Notice of Administrative Decision

RE: Permit Number: 22-00076
Project Name: Smith- 50% buffer reduction from type F stream
Type of Application: Critical Area Buffer Reduction (Type II)

ADMINISTRATIVE STAFF REPORT

Project Name: Smith Critical Area Buffer Reduction

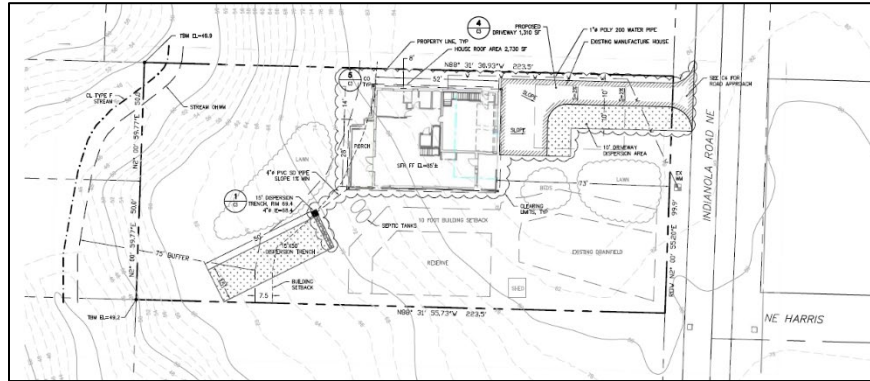
The image below shows the proposed footprint of the home and associated drainfield as well as the existing driveway. On site is an existing home which will remain during construction and then be rebuilt as a garage in its place. The site plan also shows the location of the onsite Type F stream to the west.

Site Plan

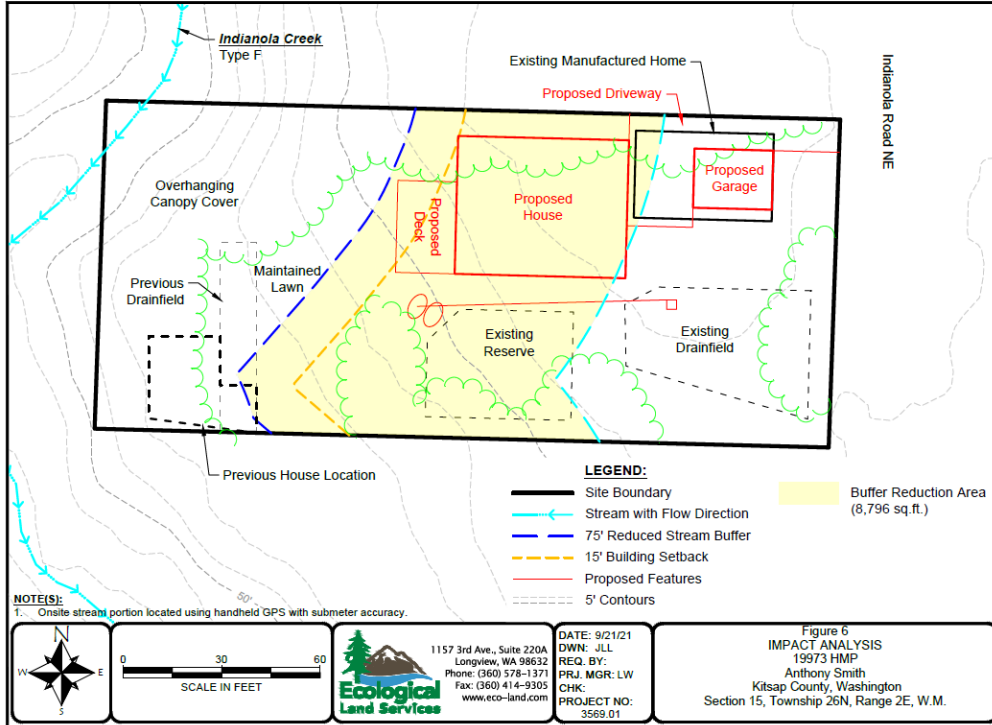
9. Due to the mapped erosion hazard area on this parcel, a non-clearing native vegetation buffer shall be maintained from the top of the slope to 25 feet beyond the top of the slope as depicted on the approved site plan, unless otherwise allowed through a Geological Assessment. In addition, a building or impervious surface setback line of 15 feet is required from the edge of the buffer.

16. As shown on the approved site plan, 1,200 square feet of added buffer area shall be provided directly to the east of Indianola Creek.
17. Vegetation planting shall occur as specified in the approved planting plan produced in support of this permit. Planting of native vegetation shall occur within the first dormant season once the permitted project has been constructed and approved. When planting is complete, the applicant must contact Development Service and Engineering Staff at (360)337-5777 for a site inspection and as-built approval. Monitoring and maintenance of the planted area shall be conducted for three years after DCD staff approves planting. Monitoring includes live and dead vegetation counts and records of all maintenance activities. Maintenance activities can be defined as, but are not limited to, removal practices on invasive or nuisance vegetation and watering schedules. Monitoring information shall be summarized in a letter with photographs depicting conditions of the vegetation and overall site. Monitoring reports are due to Kitsap County Department of Community Development Services and Engineering Division by December 31 of each monitoring year. If more than 20 percent of the plantings do not survive within any of the monitoring years, the problem areas shall be replanted, and provided with
